Project Name: **Marlboro BRF 010-1(43)**
Structure Identification: **Bridge #48 on VT RTE 9 over Whetstone Brook**

The Temporary Bridge and detour plans received in this office on January 14, 2014 have been reviewed. Please address the comments below and resubmit the plans.

PLAN AND PROFILE OF TEMPORARY BRIDGE, ABUTMENTS & BYPASS ROAD	BRF 010-1(43) ROUTE 9 MARLBORO, VT	DATE: 1-06-2014	BELL ENGINEERING CIVIL & ENVIRONMENTAL 17 ECHO COVE WAY-SPOFFORD, NH 03462 (603) 363-9966	SHEET 1 OF 9

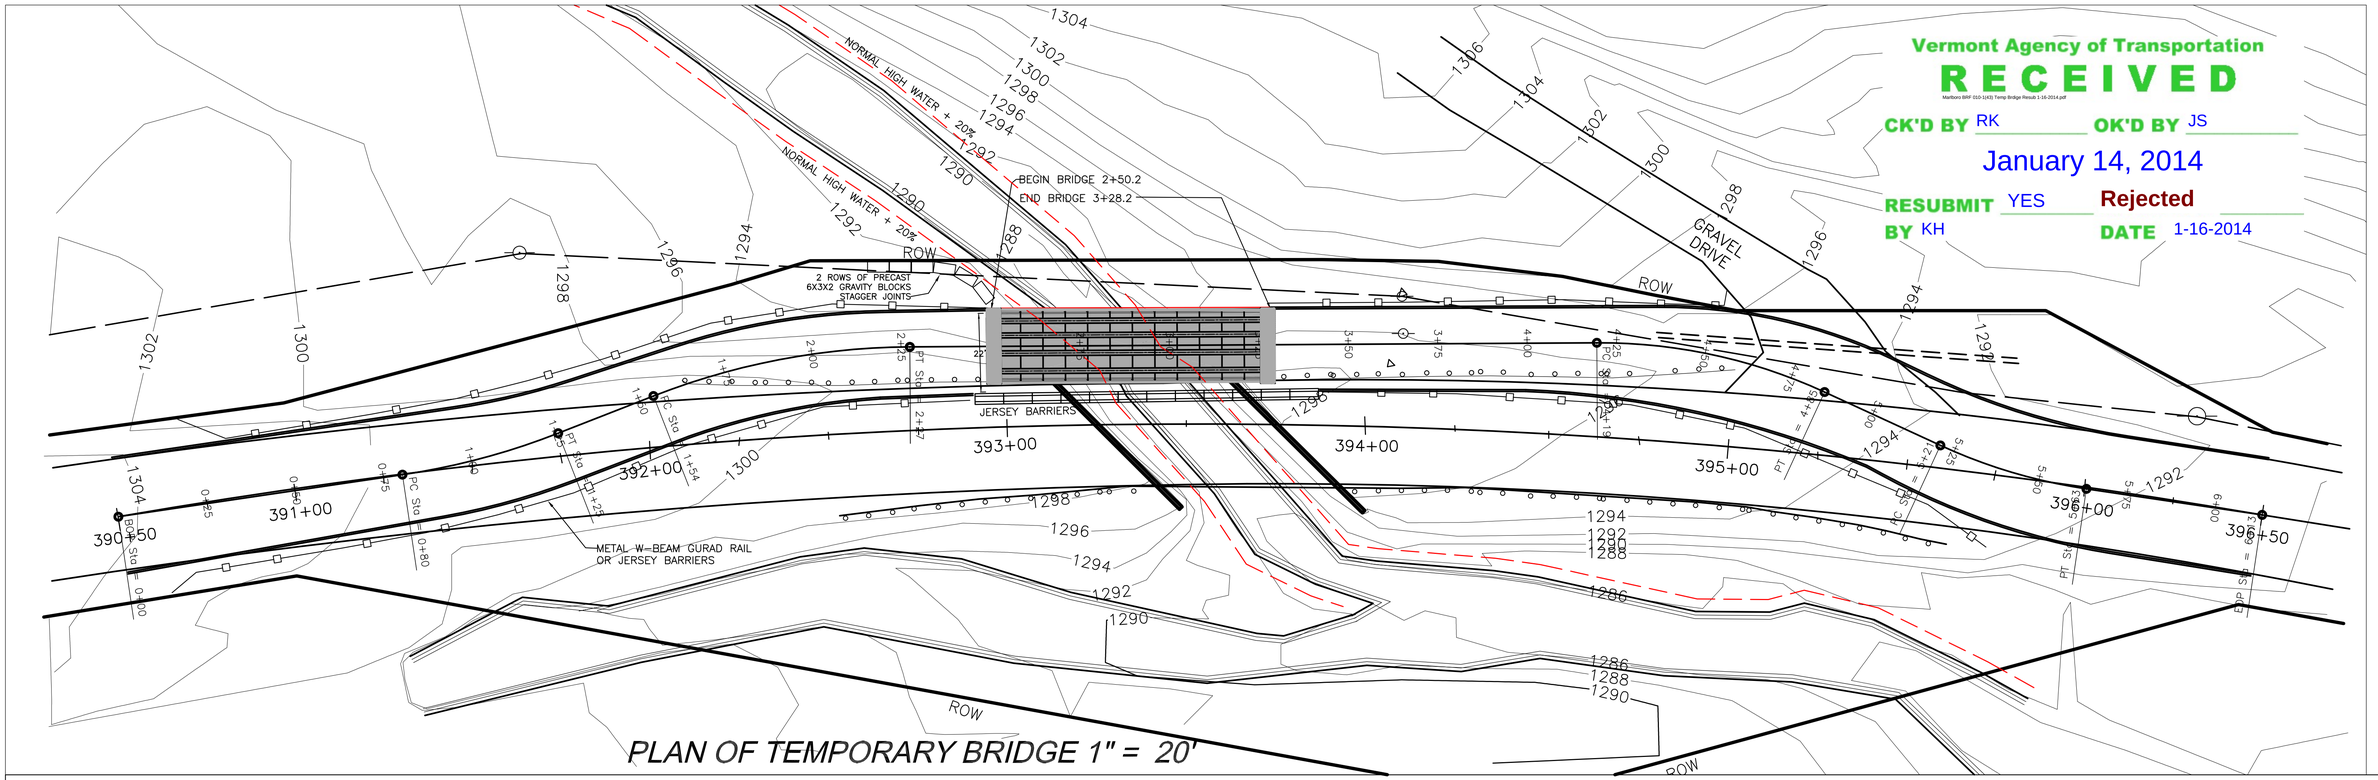
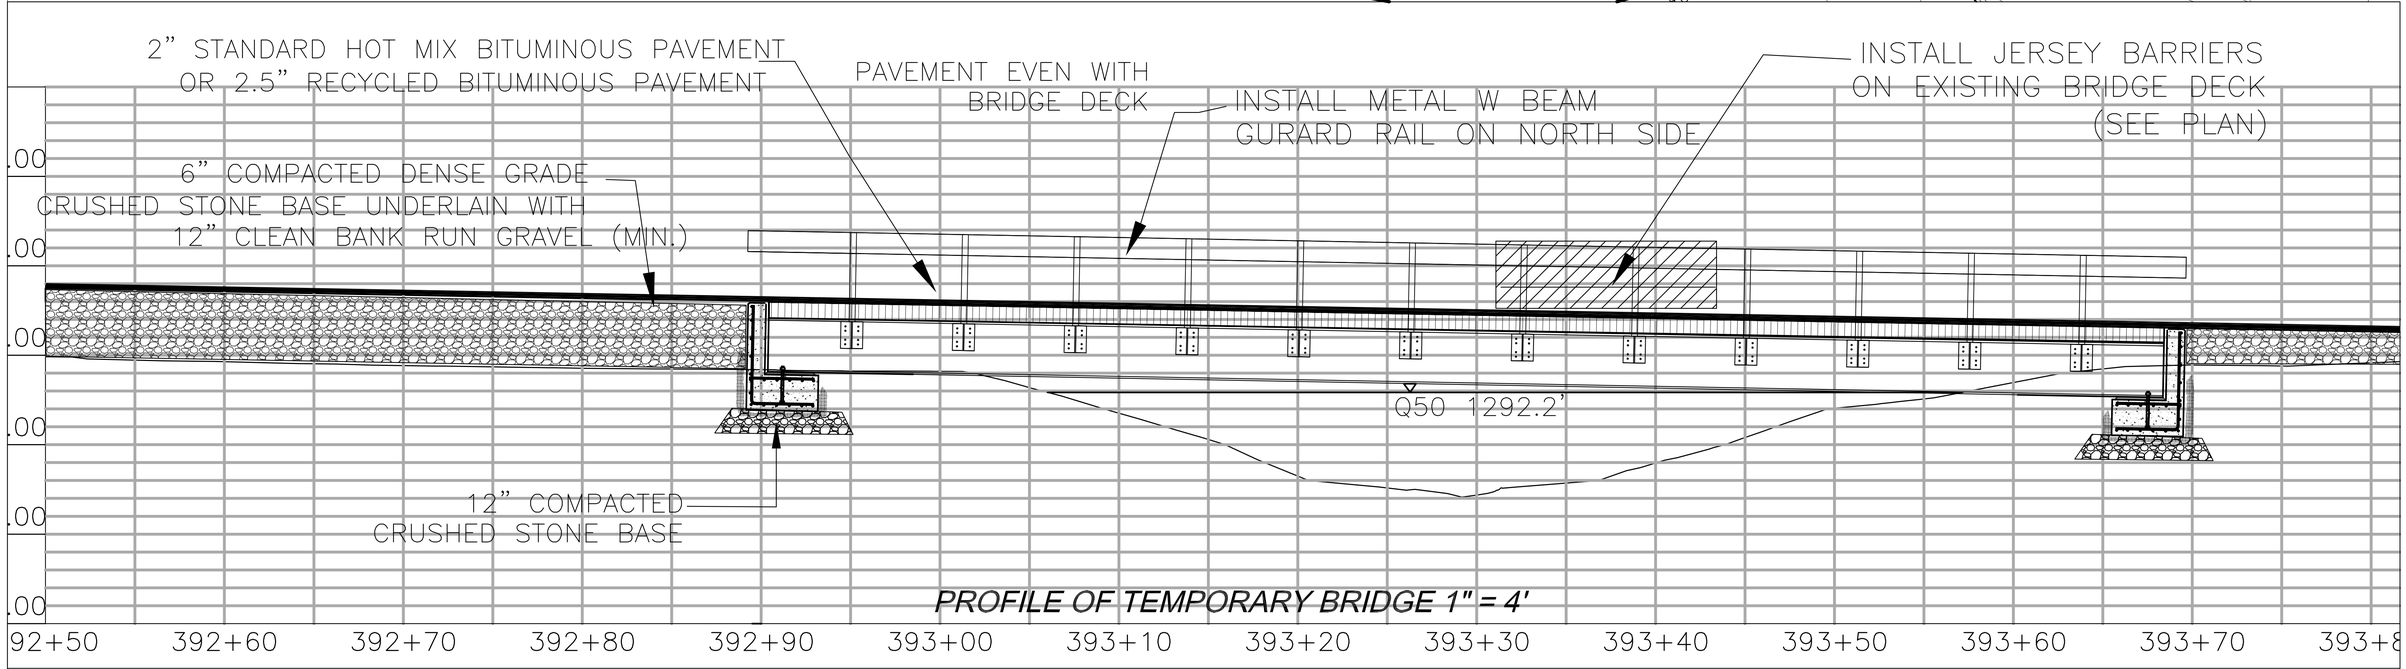
1. General:
    a. Plans need to have PE stamp per 528.04 and 105.03(3).
2. Plan and Profile Sheets:
    a. Include intended design speed.
    b. Show location of guardrail end terminals.

c. Show limits of earth disturbance.
    d. Will drive culvert for Baldwin property be removed and replaced?
3. Temporary Bridge Details Sheet:
    a. Need additional details/dimensions on bridge deck section including overall width and rail-to-rail width of temporary bridge, location of existing girder(s) used in temporary bridge, location of existing deck cut line, and location of Jersey Barrier, etc.

ABUTMENT DETAILS 1" = 2'

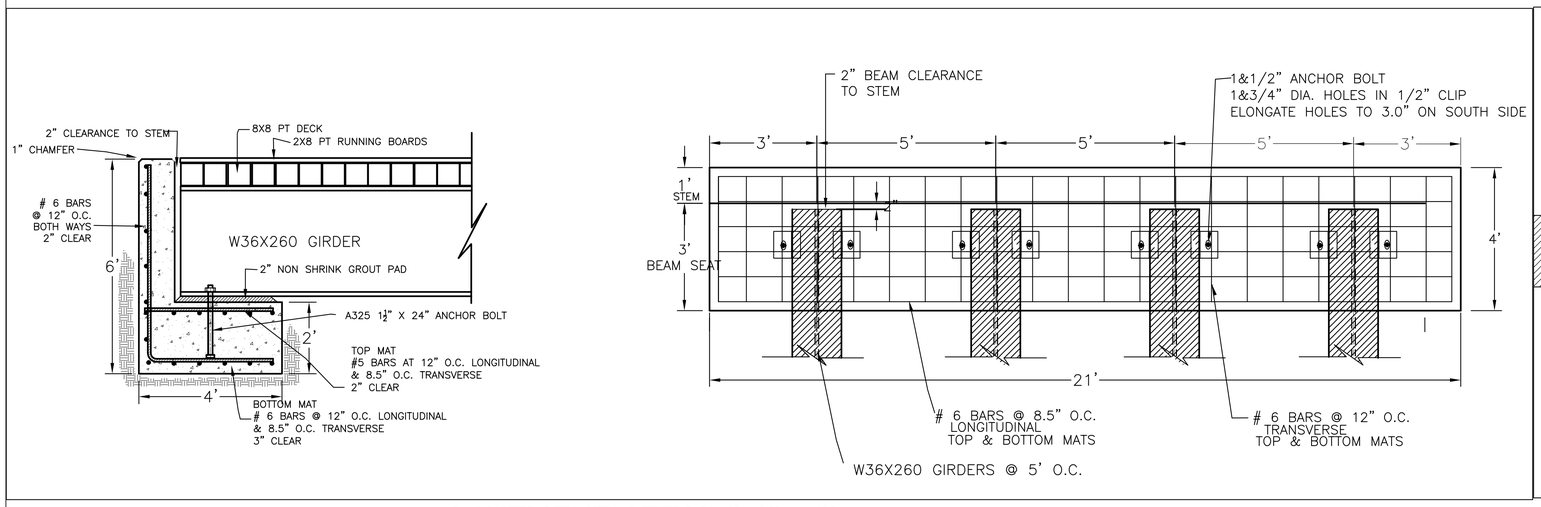
e. Indicate how the deck will be fastened to the girders.
    f. Clarify the following: bridge cross section shows PT 2x8x20' laminated deck with 3" pavement where abutment section shows 8x8 PT deck with 2x8 PT running boards.

TYPICAL DETOUR ROAD SECTION

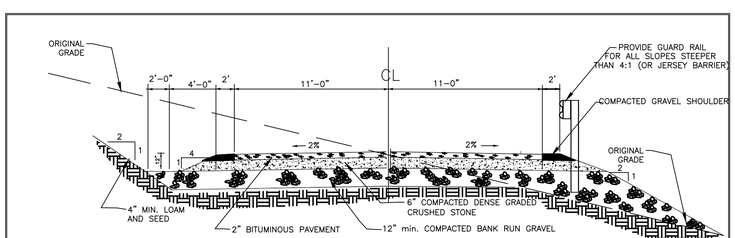
1. Use a minimum of 300' radius for curves #2 and #3 and 200' radius for curve #4.
2. Use a 3-12-12-3 cross section for the typical roadway detour transitioning to 0-12-12-0 at temporary bridge. The additional shoulder off the bridge is needed to prevent trucks from crossing the centerline.
3. As an alternative to the above options, move PI's for curves #1 and #4 out (away from temp bridge) to provide a more gradual transition.
4. Verify alignment is shown at centerline of temporary bridge. It appears to be shown at centerline of wood deck portion.

d. Guardrail in typical detour section does not show a buffer. Provide details for all temporary traffic barrier (including bridge rail) from FHWA's Roadside Hardware Policy and Guidance per 528.04(c)/621.07. All temporary traffic barrier and corresponding connections shall meet TL-3 criteria in accordance with 528.04(c)/621.07.

PLAN AND PROFILE BY PASS ROAD	BRF 010-1(43) ROUTE 9 MARLBORO, VT	DATE: 1-08-2014	BELL ENGINEERING CIVIL & ENVIRONMENTAL 17 ECHO COVE WAY-SPOFFORD, NH 03462 (603) 363-9966

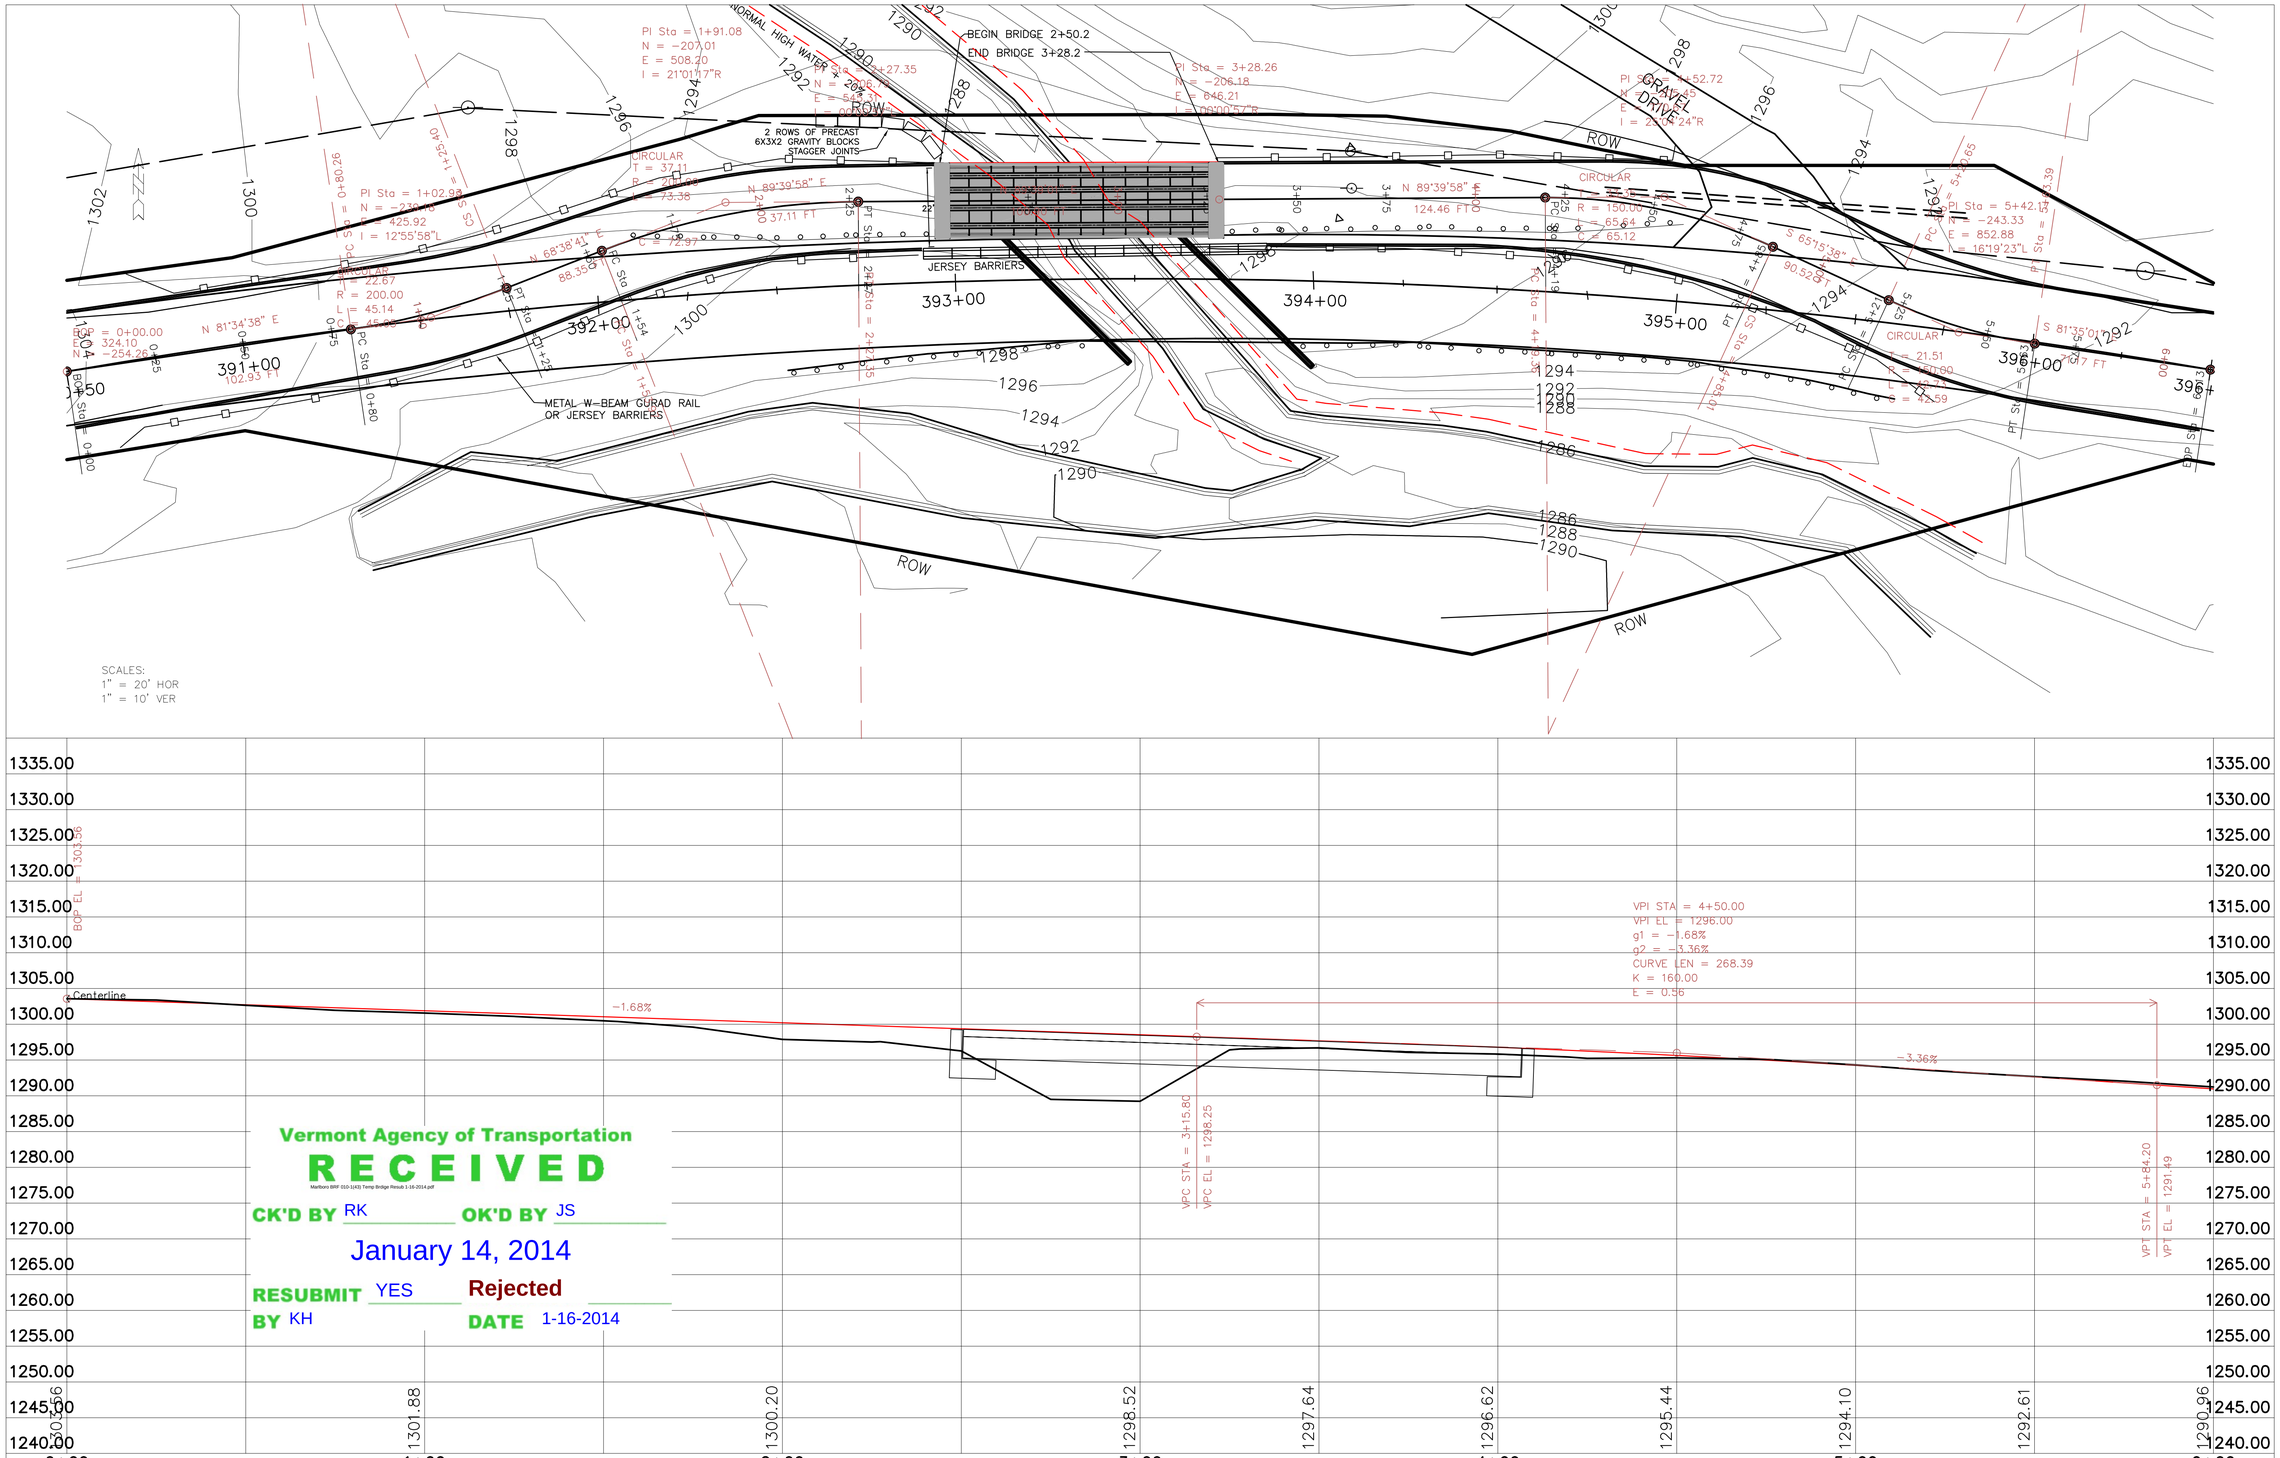
Verify location of utility pole at Station 394+10, 32' LT. The pole appears to be shown about 5 feet closer to the ROW than on the contract plans. Clarify if the intent is to relocate this pole closer to the ROW. If it will be relocated other than shown on the contract plans, show guy wire location and indicate station and offset for new pole location. The temporary guardrail appears to be very close to this pole. Verify adequate deflection distance will be provided.

Should use a wider approach cross section and increased the radii of curves #2, #3, and #4. Using AutoTrack we cannot get a semi with 53' trailer to pass at 10 MPH without crossing the centerline (see attached truck movements). Recommendations:
